Item No.: 24B-RR-05

NCUTCD PROPOSAL FOR CHANGES TO THE MANUAL ON UNIFORM TRAFFIC CONTROL DEVICES

COMMITTEE / TASK FORCE: Railroad & Light Rail Transit Technical Committee
ITEM NUMBER: 24B-RR-05
TOPIC: Detectable Warning at Swing Gates
ORIGIN OF REQUEST: RRLRT Technical Committee
AFFECTED SECTIONS OF MUTCD: Section 8E.06, Section 8E.09

51 **Figure 8E-6. Example of an Automatic Pedestrian Gate and an Emergency**
 52 **Escape Route at a Pathway Grade Crossing**

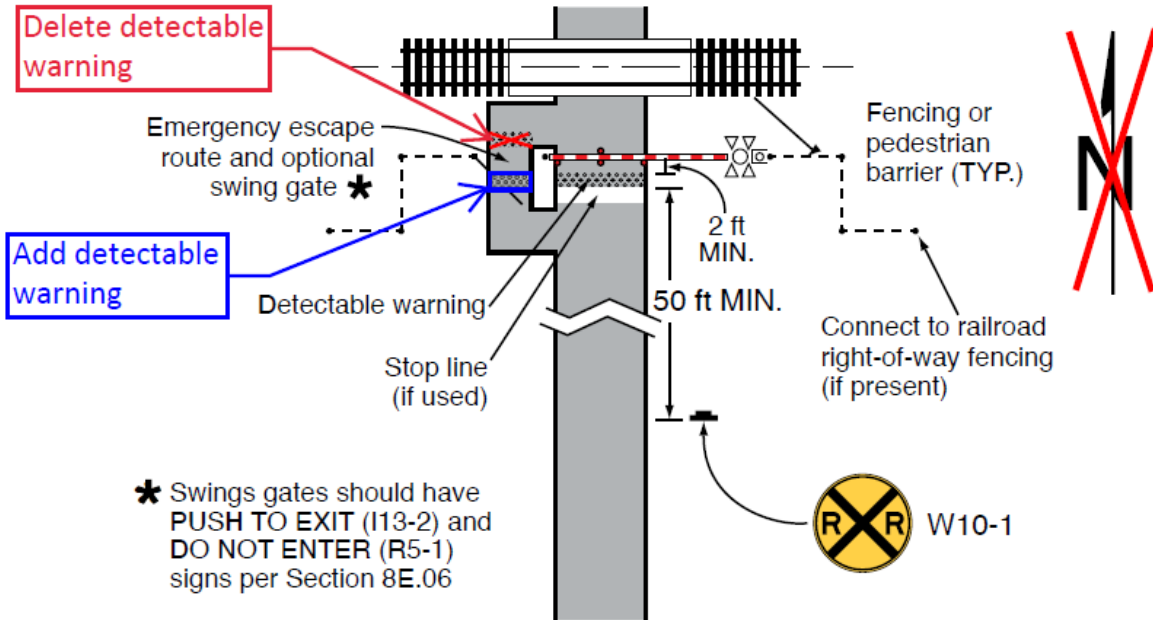
The proposal revises the placement of detectable warnings in two Part 8 figures to locate them downstream of a swing gate for consistency in the placement of detectable warnings at all grade crossings.

Figures 8E-6 and 8E-9 show the arrangement of traffic control devices at grade crossings with automatic pedestrian gates and an escape route that includes a swing gate. In both figures, the detectable warnings at the swing gates are shown on the rail side of the swing gate. Detectable warnings indicate when a pedestrian is entering and leaving a hazard area. At a grade crossing the detectable warnings on the downstream (exiting) side of the crossing need to be located where the pedestrian is clear of the crossing, which would be beyond the automatic pedestrian gate and swing gate. This proposal relocates the dateable warnings downstream of the swing gates and eliminates the North arrows because they do not add any useful information to the figures.
